NOTICE OF PUBLIC HEARING
Minor Variance

APPLICATION NO.:	HM/A-24:29	SUBJECT PROPERTY:	1395 UPPER OTTAWA STREET, HAMILTON
ZONE:	C6 Exception 346 (District Commercial)	ZONING BY-LAW:	Zoning By-law City of Hamilton 05-200, as Amended

Re – 1395 Upper Ottawa Street, Hamilton, Ontario
Minor Variance Application Submission

Re: **APPLICABLE LAW REVIEW – ZONING BYLAW RESPONSE FROM
APPLICANT IN RED TEXT BELOW IMBEDDED IN DOCUMENT -
January 16, 2024**

drawing title
SITE PLAN

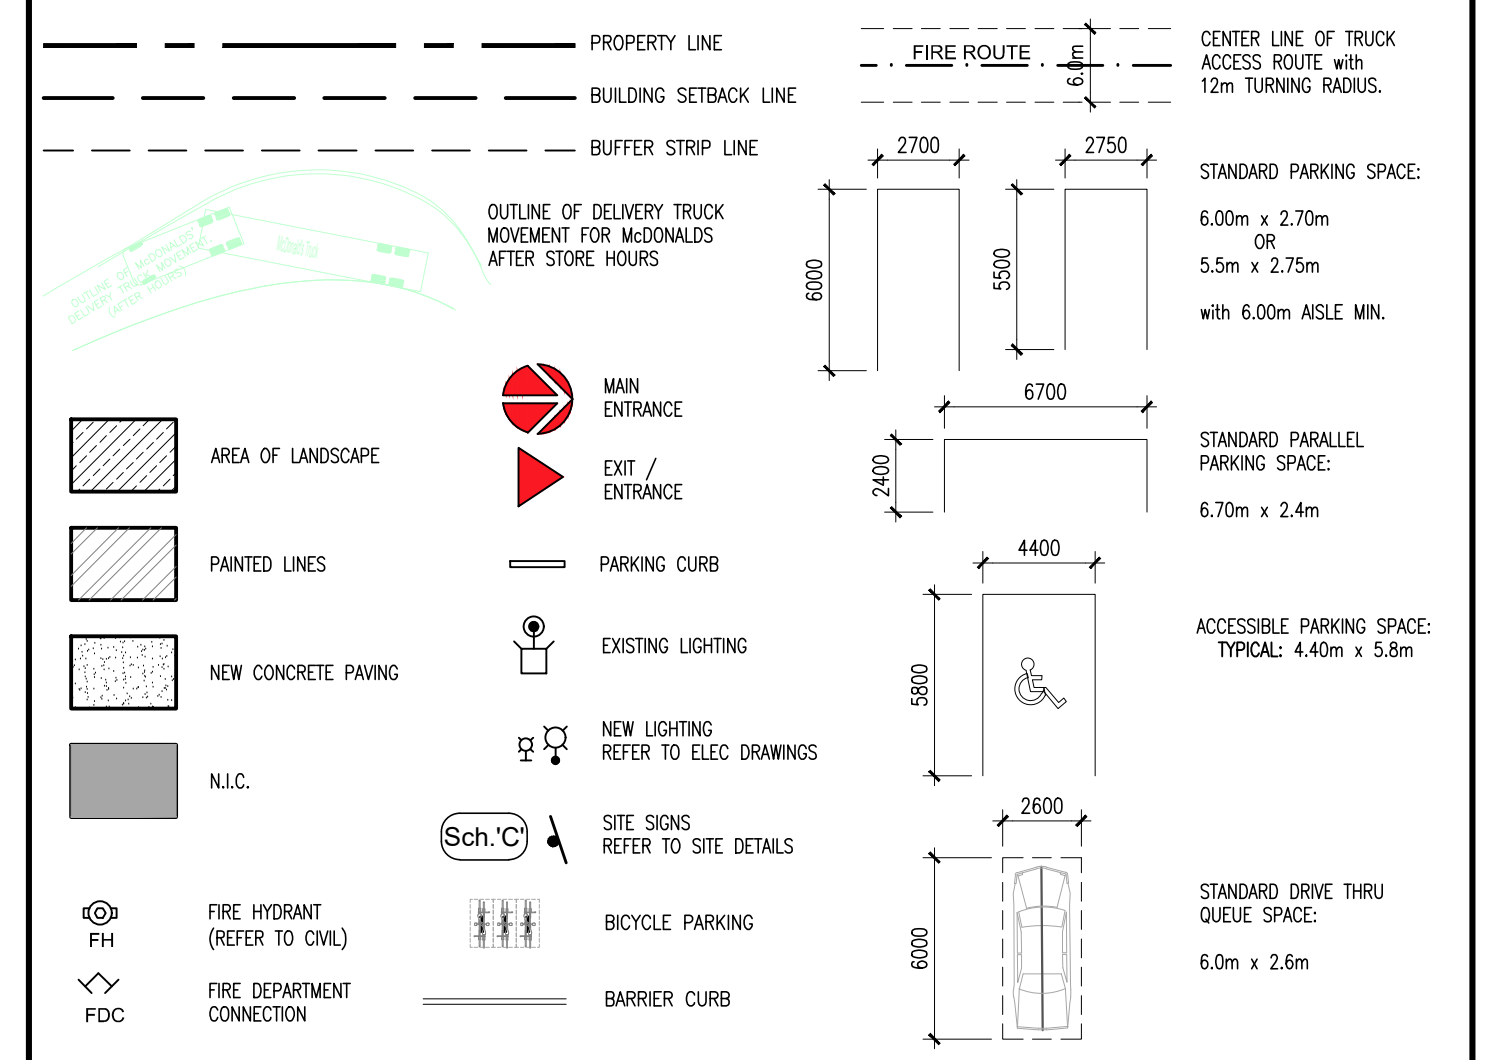
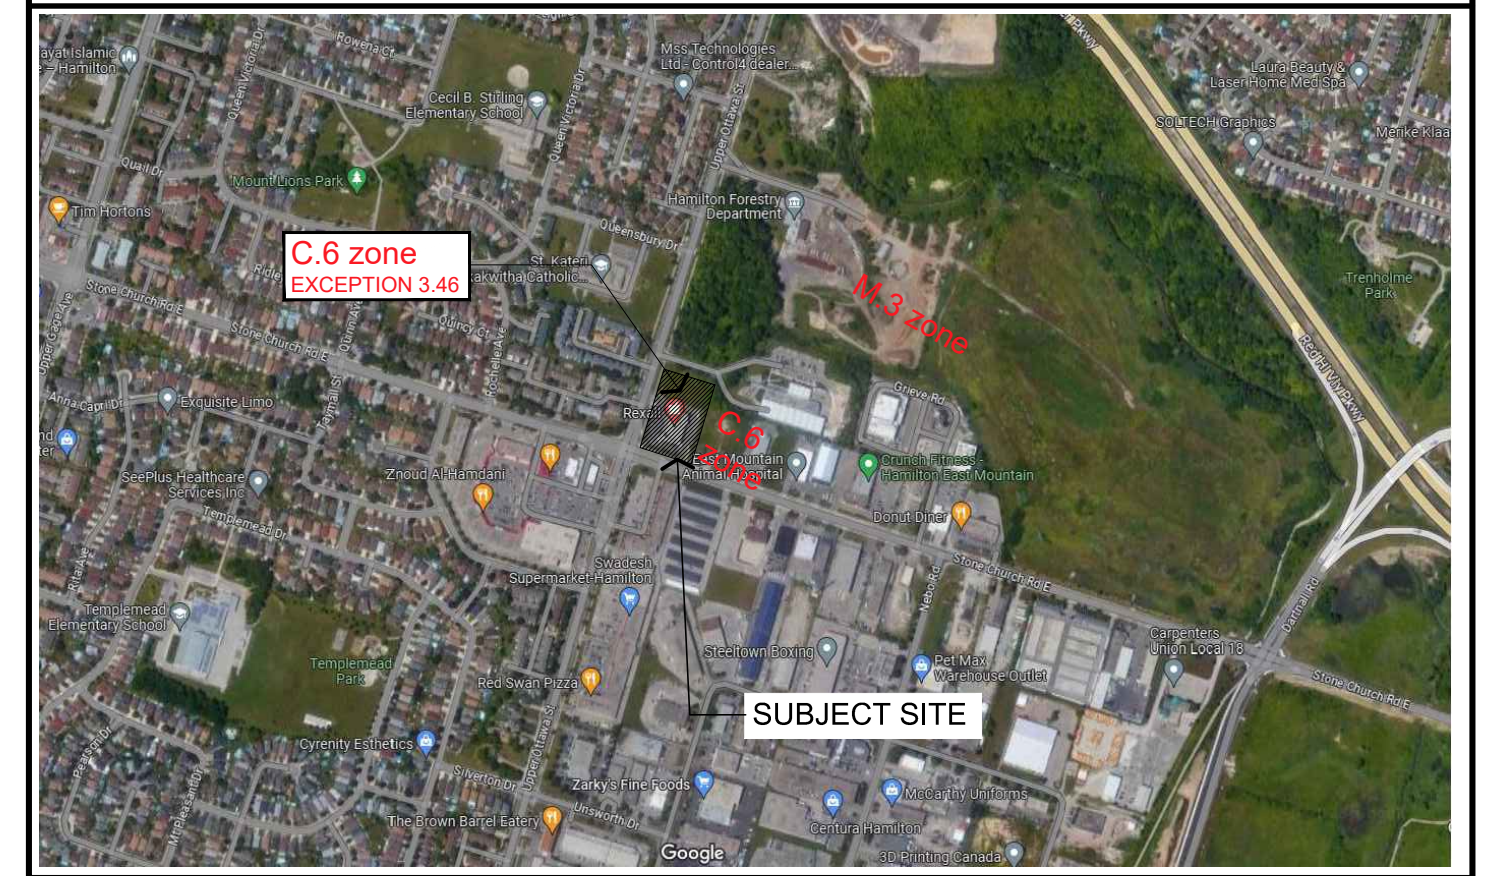
1. The applicant indicates that the proposal is to amend Phase 2 of previous approved Site Plan Control Agreement DA-12-003, originally intended for a multi-tenant building on the northern portion of the site. The proposal will facilitate the construction of a drive-thru restaurant (McDonald's) in place of the multi-tenant building on said northern portion of the subject property while maintaining the existing Phase 1 of the development consisting of retail store.

3. This is a corner lot. Therefore, the lot line abutting Stone Church Road East is considered the front lot line for this development as it is the shortest lot line abutting a street and the opposite lot line is considered the rear lot line. The lot line abutting Upper Ottawa Street is considered a flankage lot line including the hypotenuse of the daylight triangle and the remaining easterly side lot line an interior side lot line.

4. This Division has previously interpreted that the proposed garbage facilities shown (earthbins/moloks) are considered accessory structures shall comply with the requirements of Section 4.8 "Accessory Buildings" regulations of the Hamilton Zoning By-law 05-200.

5. All mechanical equipment including “transformers” shall comply with the requirements of Section 4.9 of the Hamilton Zoning By-law 05-200 and shall not be located within required landscaped/planting strip areas.

Building Setback from a Street Line [as per section 10.6.3(a) of Hamilton Zoning By-law 05-	i) Minimum 1.5 metres; ii) Maximum 4.5 metres, except where a visibility triangle is required for a	i) and ii) A maximum setback greater than 4.5m is proposed from both street line lines.	Partly non-conforming. By-law 11-271 permits a minimum westerly side yard of 3.1m. Please confirm.

Required By By-Law	Provided	Conforming/ Non-Conforming
Minimum setbacks [as per section 4.8.3 a) of Hamilton Zoning By-law 05-200]	Minimum 0.6 metres where a rear lot line does not abut a Laneway.	Significantly greater than 0.6m from the rear lot line.	Conforms
	Minimum 0.6 metres where a side lot line does not abut a Laneway.	Significantly greater than 0.6m from the side lot line.	Conforms
Drive Through Regulations – Section 4.25			
Minimum number of stacking spaces [as per section 4.25 a) of Hamilton Zoning By-law 05-200]	Notwithstanding any other provisions in this by-law, every drive through shall provide the following minimum number of stacking spaces from the service window:	The site can only accommodate thirteen (13) stacking spaces from the drive through window.	Conforming

i) Restaurant - 12 spaces		
	ii) All other uses - 3 spaces	Not applicable	N/A
Minimum stacking lane space sizes [as per section 4.25 b) of Hamilton Zoning By-law 05-200]	No stacking spaces shall be less than 2.6m in width by 6.0m in length, unless otherwise provided for in this By-law.	The stacking space sizes have not been clearly dimensioned.	Unable to determine compliance Stacking space clearly dimensioned on revised Site Plan.
Locational specific regulations [as per section 4.25 c) i) of Hamilton Zoning By-law 05-200]	i) No Drive-Through Facility shall be permitted to locate between any required parking area and the main entrance for the use;	The drive-through facility is not located between the required parking area and the main entrance for the use.	Conforms
	ii) No Drive-Through Facility stacking lane shall be permitted between the street and the building, except where other buildings on the same lot occupy the space between the Drive-Through Facility and a street;	The proposed drive-through facility is not shown to be located between the street and the building.	Conforms

iii) Required stacking spaces shall not be permitted in any aisle providing access to the required parking nor obstruct the ability to access a parking space; and,	The proposed stacking spaces do not appear to interfere with the driveway aisle providing access to a required parking space.	Conforms
	iv) No Drive-Through Facility, including the stacking space, and any access driveway or manoeuvring space to provide access to the Drive-Through Facility, shall be permitted less than 12.0 metres from a Residential Zone measured from the property line of the lot containing the Drive-Through Facility abutting a Residential Zone or where the lots are separated by a public street, from the lot line closest to the Residential Zone.	This property is located a distance greater than 12.0m from a Residential zone.	N/A

<p>h) <i>In addition to Section 5.1 a) v) and Subsection 5.2 e), the following Planting Strip requirements shall apply to surface parking lots in all zones where 50 or more parking spaces are provided on a lot::</i></p> <p>i) Landscaped Area(s) or Landscaped Parking Island(s) with a minimum combined area of 10% of the area of the parking lot and associated driveway and maneuvering areas shall be provided and maintained;</p> <p>ii) Each Landscaped Area and Landscaped Parking Island shall have a minimum area of 10.0 square metres;</p> <p>iii) In addition to Section 5.6, the number of required parking spaces required to accommodate the Landscaped Area or Landscaped Parking Island within the parking lot shall be reduced by the amount needed to accommodate the minimum Landscaped Parking Island requirement as required by Subsection 5.2h)i), up to a maximum of 10% of the required parking spaces.</p>	<p>The new proposed surface parking area is less than 64 parking spaces.</p> <p>i), ii) and iii) Insufficient details provided.</p>	<p>Unable to determine compliance</p> <p>h) The new proposed restaurant surface parking area will accommodate 64 parking spaces as shown on revised Site Plan.</p> <p>i) Landscape area has been calculated as 20.9% of the proposed restaurant area of the Site.</p> <p>ii) Each landscape parking island has a minimum 10.0 sqm and is shown on the revised Site Plan.</p> <p>iii) N/A</p>
